Aviation Technical Bulletin

86-13
Supersedes 81-4

CHAMPION SPIN-ON FILTERS WITH OF712 INSTALLATION

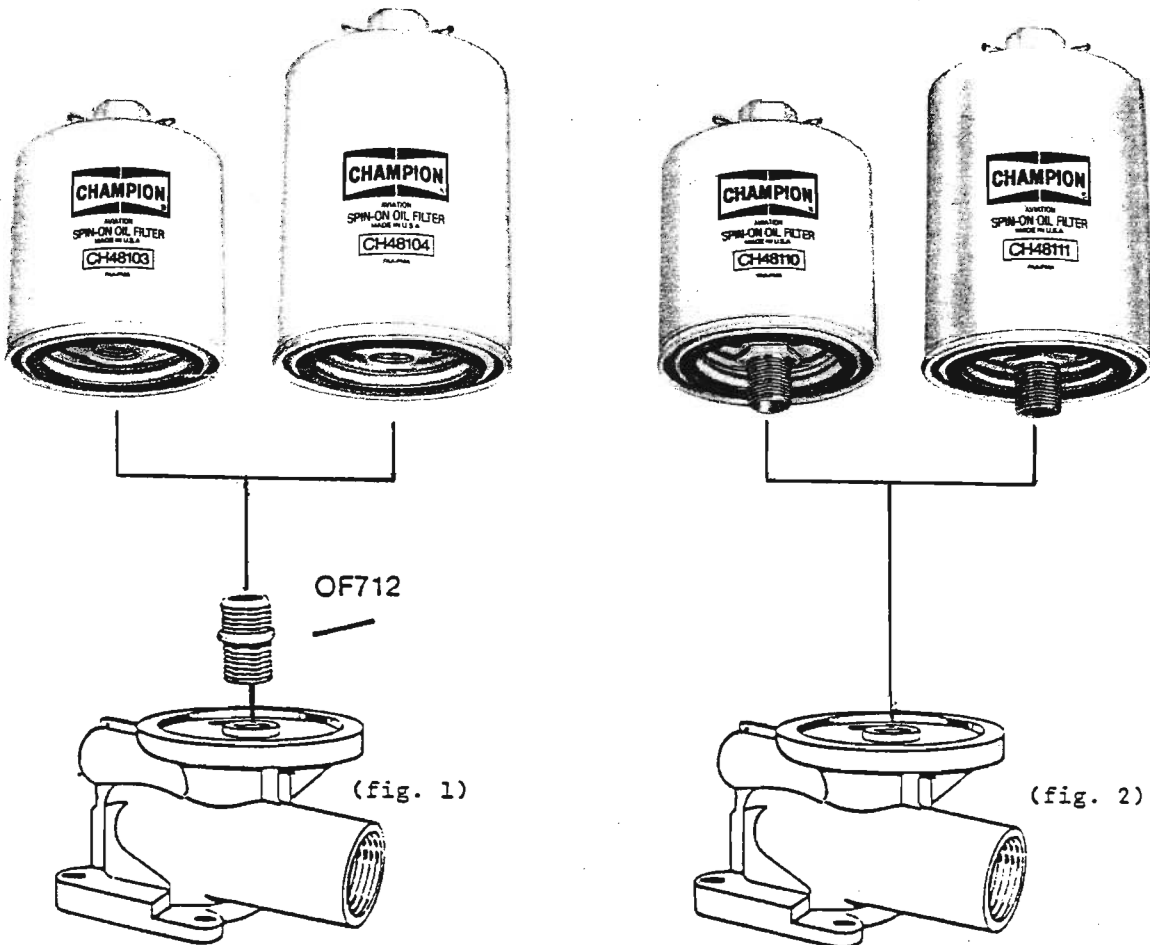
WHEN REMOVING AN AC OF51 OR OF61 SPIN-ON OIL FILTER WITH THE OF712 STUD INSTALLED, REPLACE IT WITH THE CHAMPION CH48103 OR CH48104 FILTER (FIGURE #1) - OR REMOVE THE OF712 STUD AND USE THE CHAMPION CH48110 OR CH48111 FILTER (FIGURE #2).
